Recall Bulletin

PRODUCT SAFETY RECALL

SUBJECT: Loss of Battery Charge – Inspect Generator Control Module

MODELS: 2012-2013 Buick LaCrosse, Regal
2013 Chevrolet Malibu Eco
Equipped with eAssist

Important Part Inspection

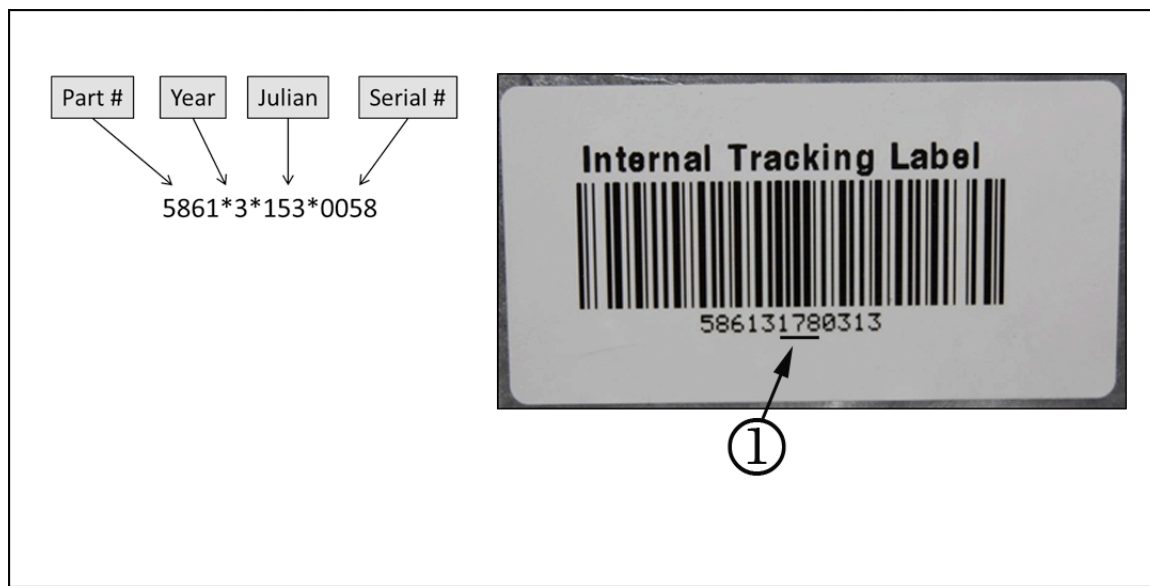
Generator Control Modules (GCM) with part number 24269448 or 24266403 require an inspection prior to installation in a vehicle. GCMs with part number 24267940 or 24267941 do NOT require inspection prior to installation in a vehicle.

Do NOT provide technicians with GCMs (p/n 24269448 or 24266403) that have a Julian date of 171 through 199. Determine the Julian date following the steps below. Return modules that fail the inspection according to Special Return Bulletin #G_0000171850.

1. Locate the barcode label on the new GCM.

2. Determine the Julian date (1) as shown above.
 - If the Julian date (1) is 171 through 199, do NOT install the module. Obtain another module and perform the inspection again.
 - If the Julian date (1) is NOT 171 through 199, provide to the technician for installation in the vehicle.

Part Inspection Procedure

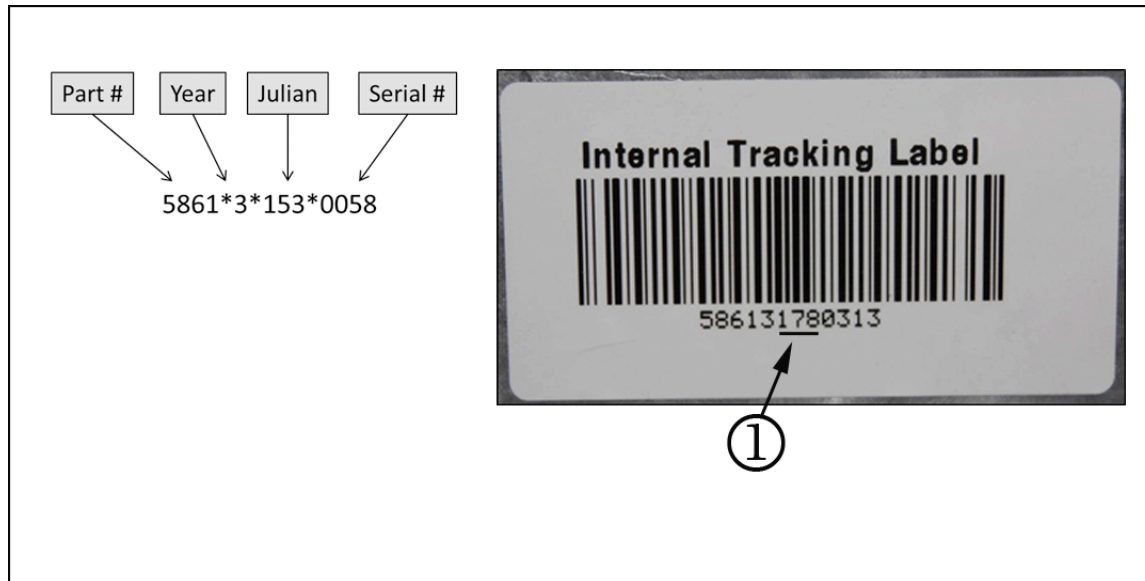
Note: Do NOT install GCMs with a Julian date of 171 through 199. Return those modules according to Special Return Bulletin #G_0000171850.

3. Locate the barcode label on the new GCM.
4. Determine the Julian date (1) as shown above.
 - If the Julian date (1) is 171 through 199, do NOT install the module. Obtain another module and perform the inspection again.

- If the Julian date (1) is NOT 171 through 199, the module can be installed in the vehicle.
1. Install GDS2 to vehicle. Start engine and confirm the vehicle has enough fuel for the drive cycle and 2 hour idle test. A quarter-tank of fuel is required to complete the test. Add fuel as required.
